Subject: EDITED: Written Supplemental to X.I.V.c Permit Extensions - please retain original email formatting. PLEASE USE THIS

Re: Opposition to Permit Extensions

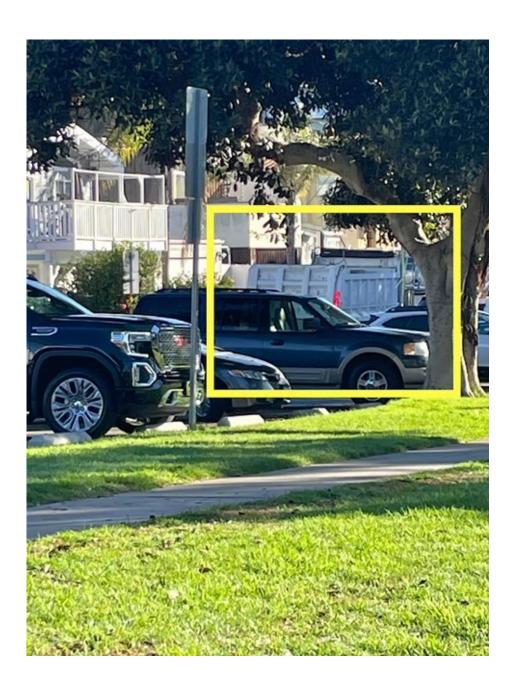
Above is a truck stuck in the backup

Four minutes later the same truck has barely moved. Check the photo's metadata for yourself.

Three minutes later that same truck (yellow rectangle) still had not reached valley drive.
